ADDENDUM NO. 2 TO PROJECT NO. 44225

ELECTRICAL WORK

**PROVIDE PEDESTRIAN SALLYPORT,
FENCING AND SECURITY MODIFICATIONS
MOHAWK CORRECTIONAL FACILITY
6514 STATE RTE. 26, ROME, N.Y.**

January 27, 2012

SHEET TITLE
 CORRECTIONS TO SHEET C-201

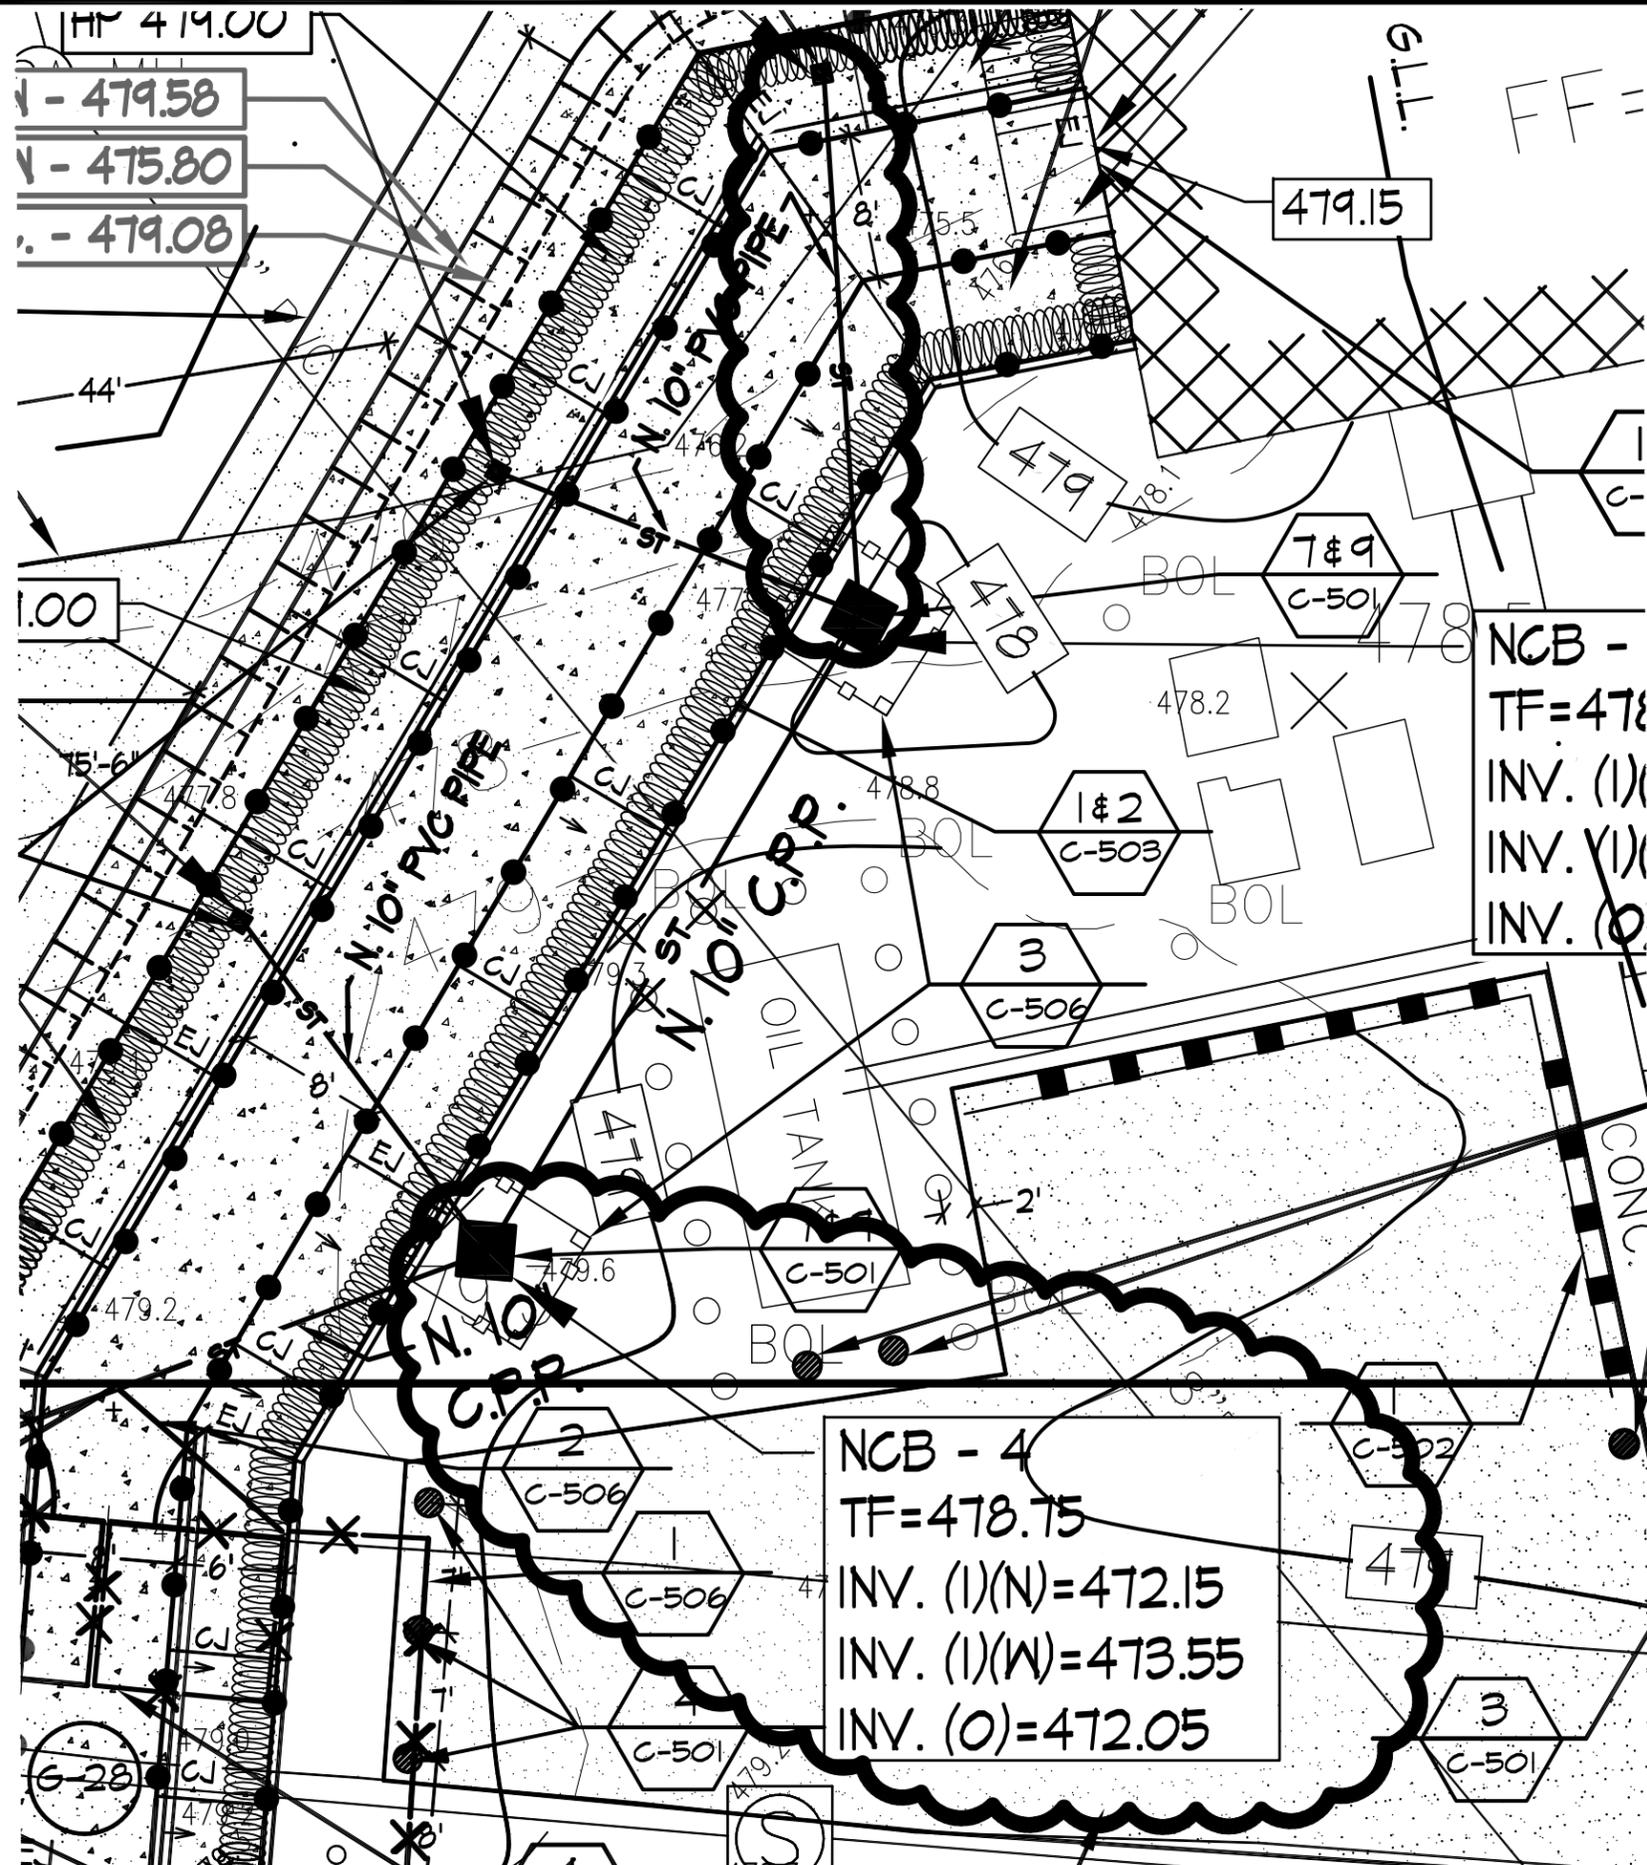
1. DRAWING C-201:
 - a. Plan titled "MOHAWK CORRECTIONAL – GRADING AND UTILITY PLAN", change designation of catch basin labeled NCB-3 to NCB-4 as indicated on the attached Addendum Drawing No. C-201A. Change top of frame (TF) elevation and invert (INV.) elevations as indicated on the attached Addendum Drawing No. C-201A.

- b. Plan titled "MOHAWK CORRECTIONAL – GRADING AND UTILITY PLAN", provide 'N. 10" PVC PIPE' from catch basin NCB-3 as indicated on the attached Addendum Drawing No. C-201A.

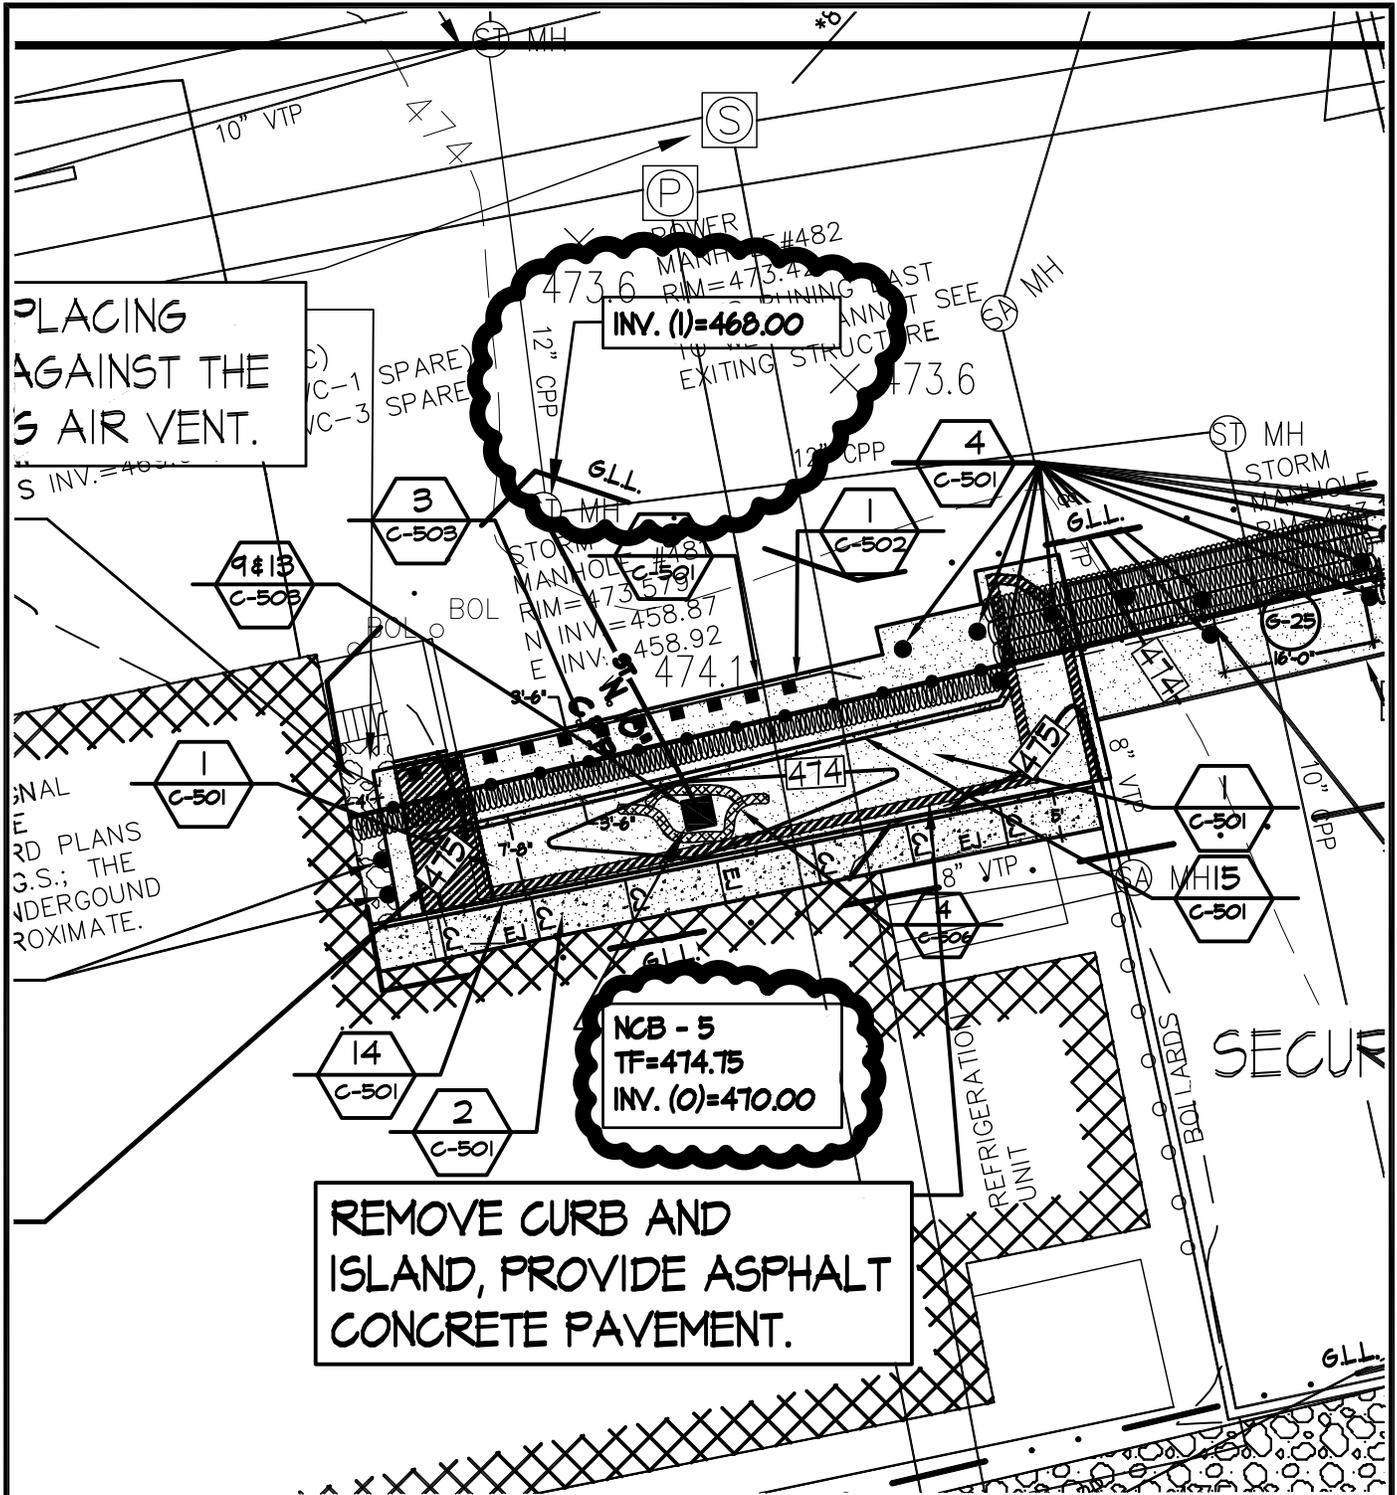
3. DRAWING C-203:
 - a. Plan titled "MOHAWK CORRECTIONAL – GRADING AND UTILITY PLAN", change designation of catch basin labeled NCB-4 to NCB-5 as indicated on the attached Addendum Drawing No. C-203A.

- b. Plan titled "MOHAWK CORRECTIONAL – GRADING AND UTILITY PLAN", change invert as indicated as "INV. (I)= 472.00" to "INV. (I)= 468.00" as indicated on the attached Addendum Drawing No. C-203A.
